IEEE P802.15
Wireless Personal Area Networks

Project	IEEE P802.15 Working Group for Wireless Personal Area Networks (WPANs)	
Title	TG3 LB19 comment resolution	
Date Submitted	[1 October, 2002]	
Source	[James P. K. Gilb] [Apparent Technologies] [9921 Carmel Mountain Rd. #247, San Diego, CA 92129]	Voice: [858-538-3903] Fax: [858-538-3903] E-mail: [gilb@ieee.org]
Re:	[]	
Abstract	[This document is a record of comment resolutions for LB19.]	
Purpose	[To provide a record of the comment resolution for LB19.]	
Notice	This document has been prepared to assist the IEEE P802.15. It is offered as a basis for discussion and is not binding on the contributing individual(s) or organization(s). The material in this document is subject to change in form and content after further study. The contributor(s) reserve(s) the right to add, amend or withdraw material contained herein.	
Release	The contributor acknowledges and accepts that this contribution becomes the property of IEEE and may be made publicly available by P802.15.

Figure 6—PNC handover MSC

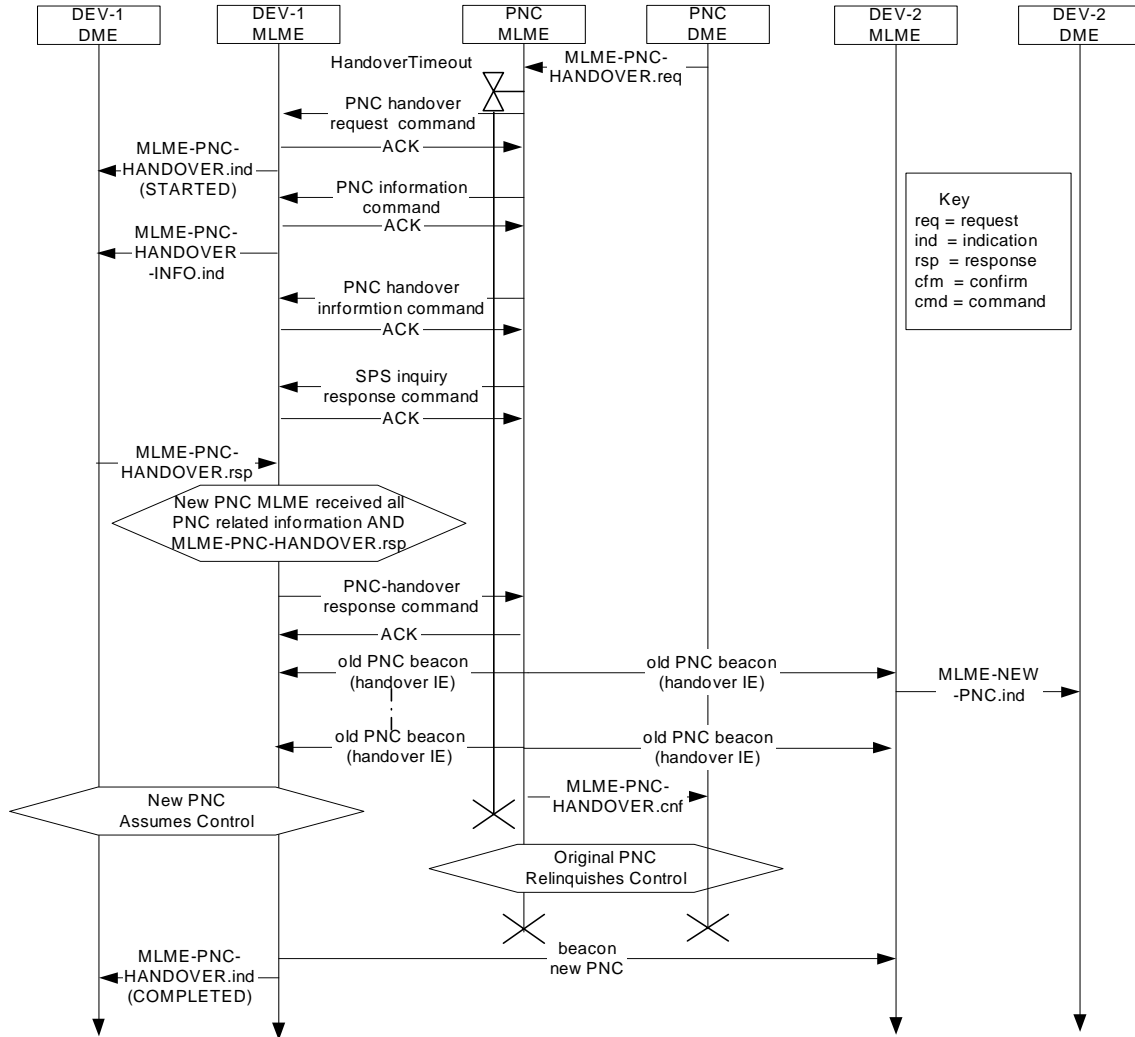
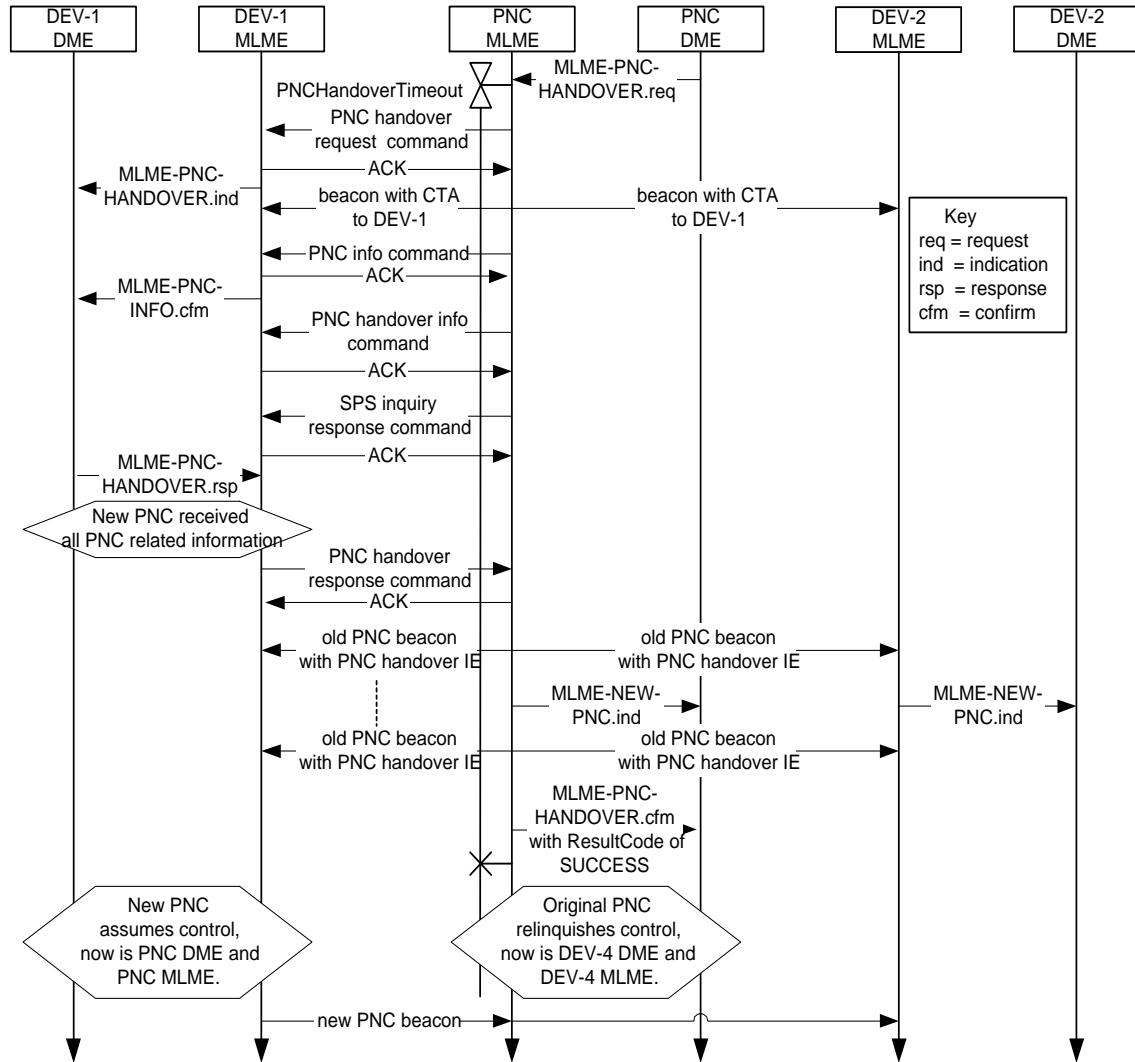
13
 14 269 (Heberling, TR) - [PNCHndOvr] Some errors in text remain or were introduced after LB17.MSC in Fig-
 15 ure 91 is also wrong./KO Text changes for 8.2.3 and ne MSC for Figure 91 are all collected in:02276r7P802-
 16 15_TG3-commentsD11_KO.doc, Resolution [03]. **Suggest accept in principle**, “The MSC will be modified
 17 as indicated in the resolutions of CID 58 and 232. Make the following text changes: In 6.3.13.4, page 59,
 18 line 45, change ‘This primitive informs the originating DME its request for information from the PNC is
 19 complete.’ to be ‘This primitive informs the DME that the MLME has received a PNC information com-
 20 mand, {xref 7.5.4.2}.’ In 7.5.3.1, page 138, line 20 ‘the number of information records to be transferred
 21 using the PNC information command frame(s).’ to be ‘the number of DEV information records, {xref PNC
 22 handover info command}, that will be transfered from the old PNC to the new PNC.’ In 8.2.3 PNC Han-

463 (Gubbi, TR) - Figure-91 is a well done job, but the text needs to supplement some info that can not be expressed in the figure, which is incomplete in the current update to this para. It should be mentioned that these commands shall be sent by PNC even if there is no information present that fits into those commands so that the rx-DEV knows the exact end of the transaction. For example, what if there are no DEVs in power save mode. Still the SPS-inquiry-response-command shall be sent by PNC. It should be mentioned that the three commands in Figure-91 (PNC-info-command, PNC-handover-info-command and SPS-inquiry-response-cmd) shall be sent by PNC even if there is no information present that fits into those commands so that the rx-DEV knows the exact end of the transaction. For example, what if there are no DEVs in power save mode. Still the SPS-inquiry-response-command shall be sent by PNC. **Suggest accept in principle**, "Rather than send the empty commands, the PNC handover request will contain the number of CTRBs and SPS sets that will be transferred. If the number of items is zero, then the old PNC shall not send the command and the new PNC will not expect to receive it. It is not possible for the number of DEVs to be less than 2 (i.e. the old PNC and the new PNC), so the PNC information command will always be sent. This is documented in the resolution of CID 269."

23 dover, delete page 156, line 8-9, redundant, same text in paragraph below. Add to page 156, line 19, ‘The
 24 PNC handover information command shall not be sent if the PNC has indicated in the PNC handover request
 25 command that it does not have any CTRBs to transfer.

26
 27 The SPS inquiry response command shall not be sent if the PNC has indicated in the PNC handover request
 28 command that it doesn’t have any SPS sets to transfer.’

29
 30 Add to page 156, line 35, ‘The new PNC shall broadcast its first beacon at the time the beacon would have
 31 been sent by the old PNC. This time may vary from the actual time due to clock inaccuracies of old and new
 32 PNCs. The new PNC shall start sending beacons with the beacon number counter set to one more than the
 33 beacon number of the last beacon that will be sent by the old PNC.’

34
 35 Add page 156, line 40ff, ‘The PNC shall ensure that the beacon countdown includes at least one system
 36 wake beacon and at least aMaxLostBeacons beacons following that system wake beacon. The only excep-
 37 tion to this requirement is if the PNC will be shutting down and does not have enough time to to wait for the
 38 next system wake beacon to complete the handover process. {Ed. note: This line may be moved to a new
 39 8.1.1 that describes all beacon announcements.’}
